ADDENDUM NO.: 01
PROJECT NAME: Lincoln Park High School Renovation Project
PROJECT NO.: 05085
CONTRACT NO.: C1582
DATE OF ISSUE: April 27, 2017

NOTICE OF CHANGES, MODIFICATIONS, OR CLARIFICATIONS TO CONTRACT DOCUMENTS

PBCC Project No.: 05085

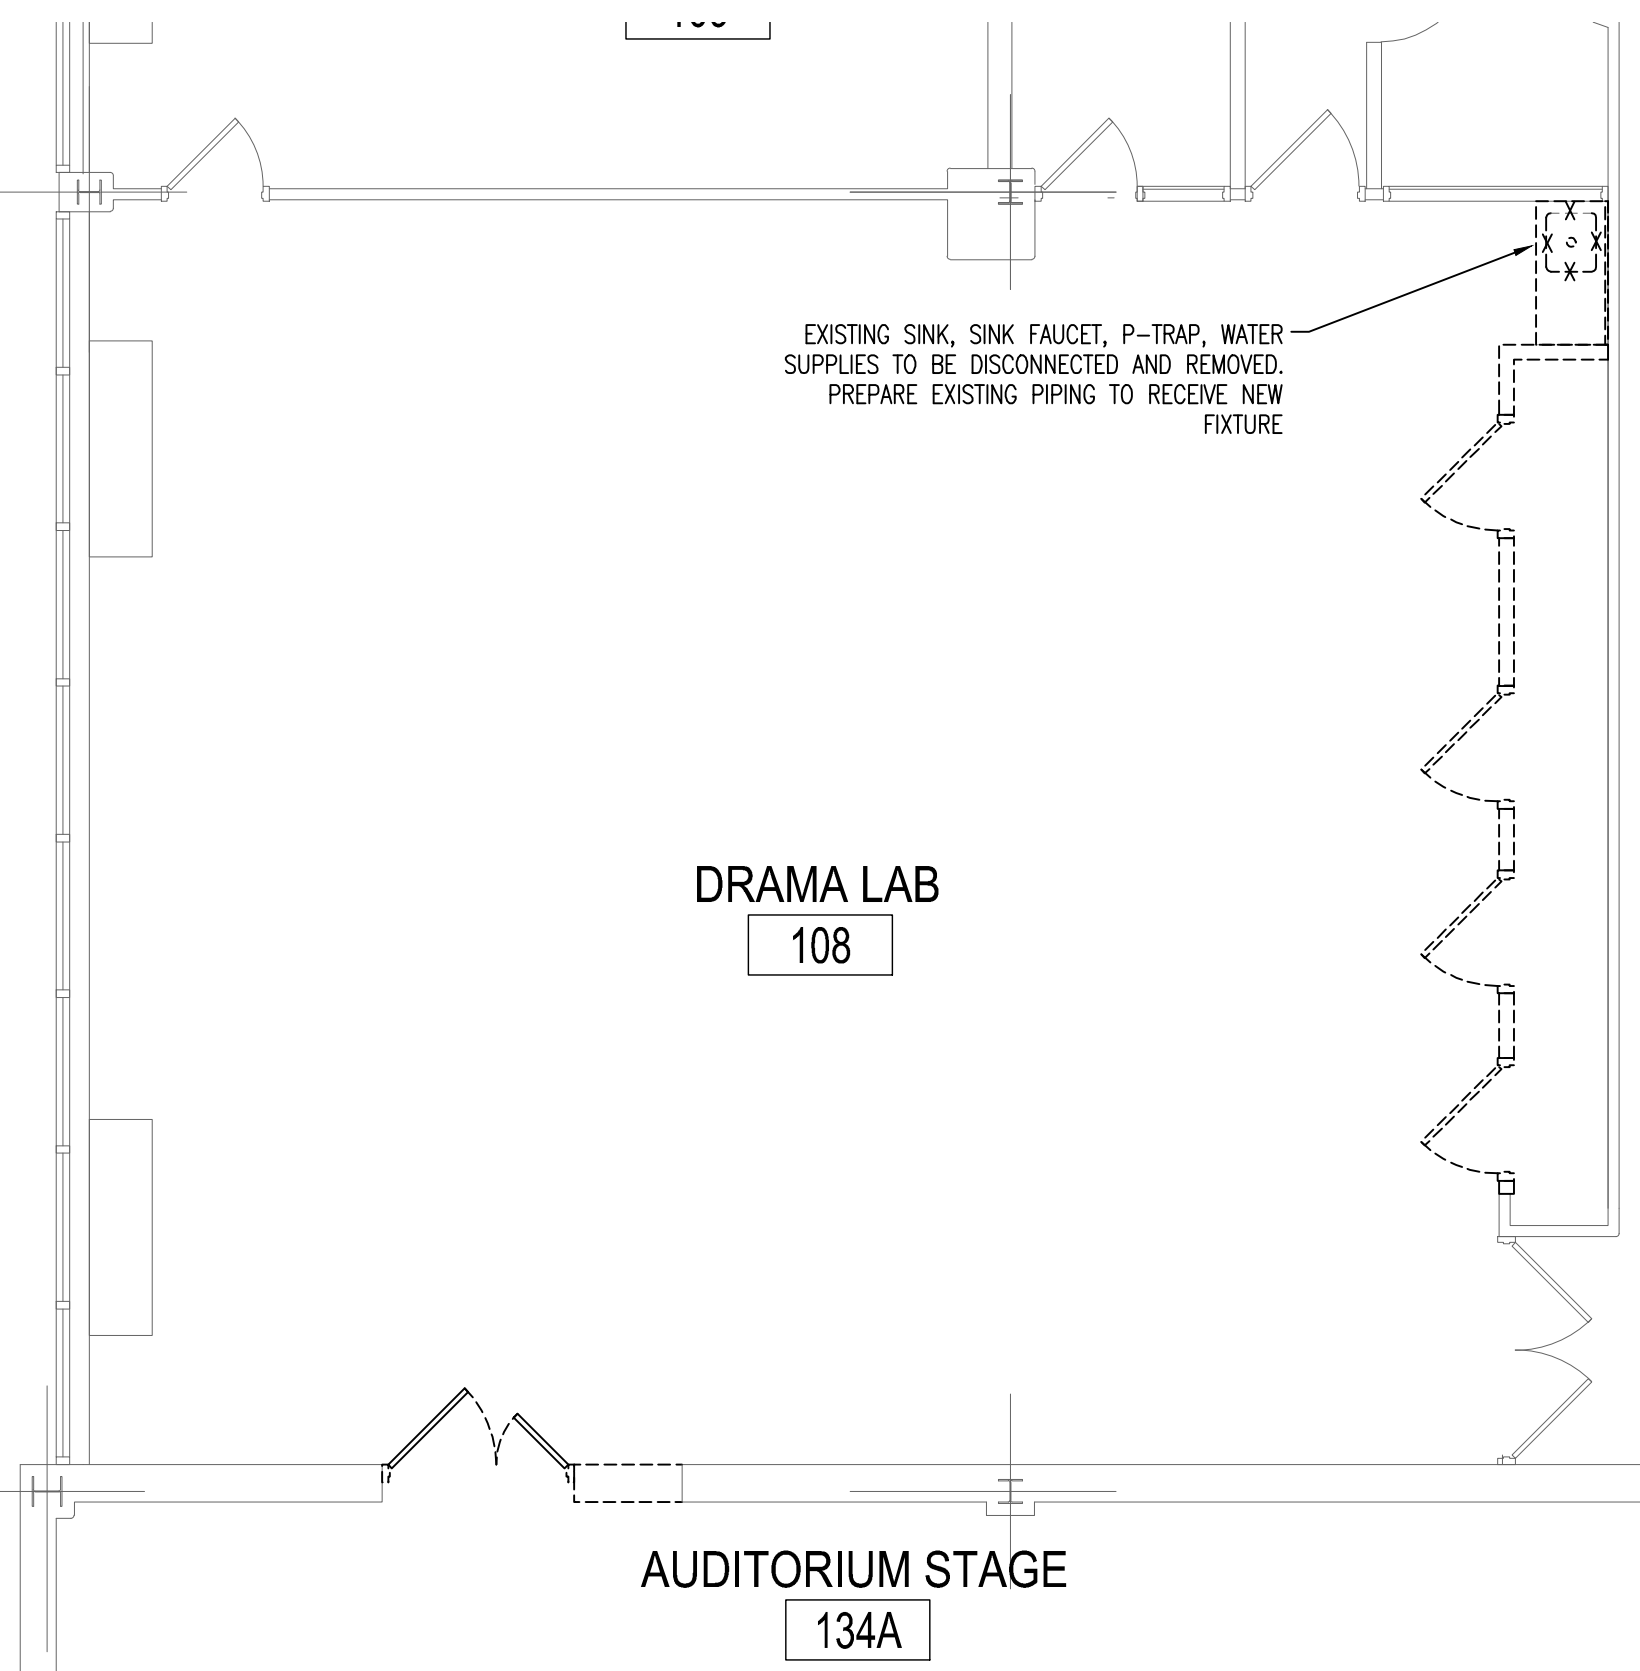
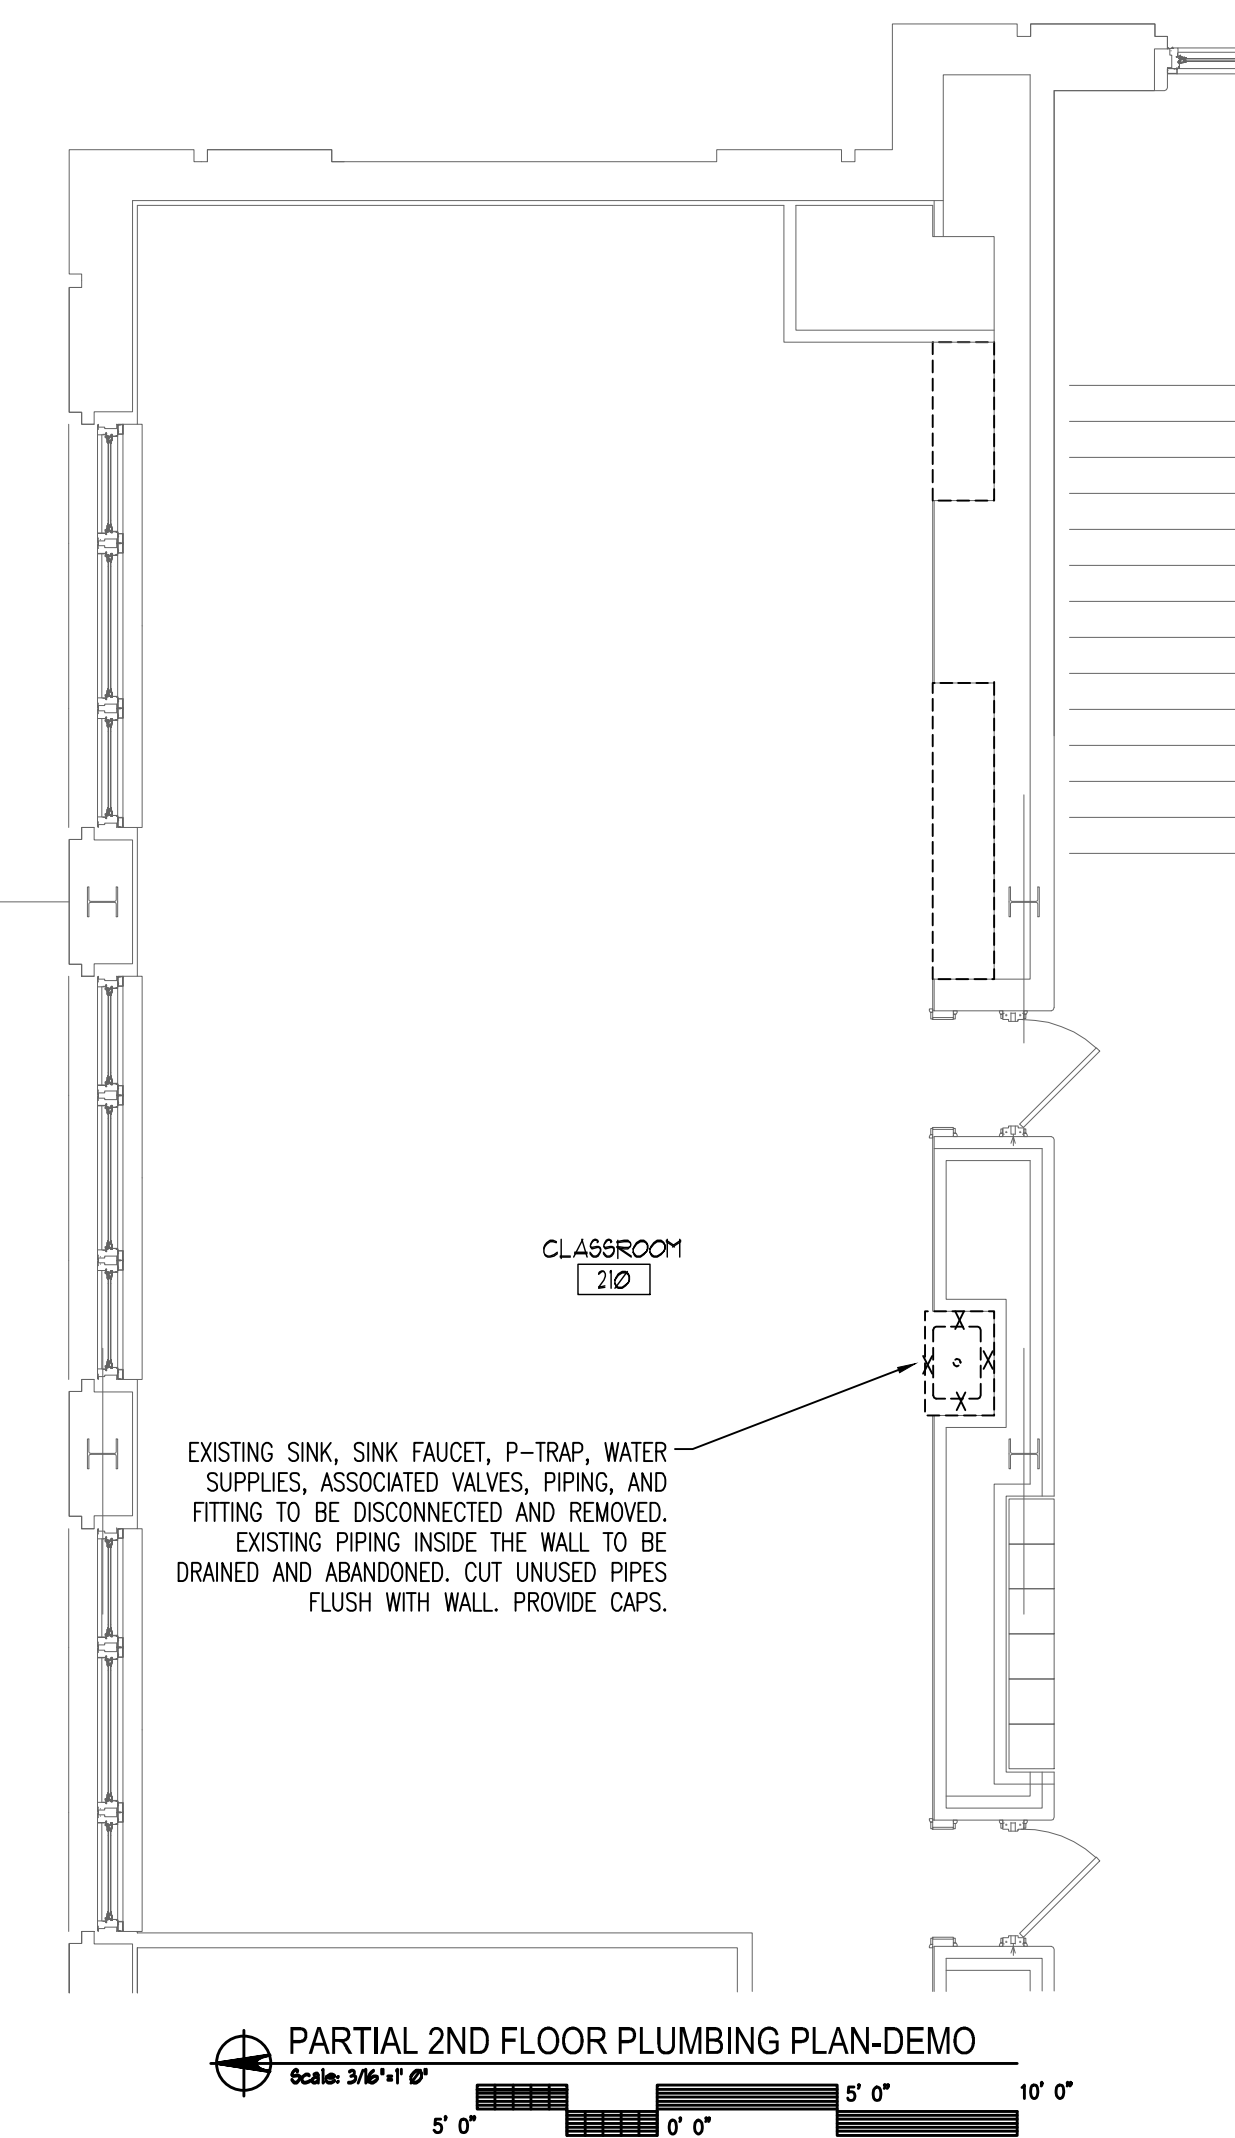
- Change No. 23 Sheet P0.03 ADD: Removal and replacement of fire protection piping and sprinklers in Distance Learning 219.
- Change No. 24 Sheet P1.02 ADD: Removal and replacement of vertical storm water pipe located in Basement.
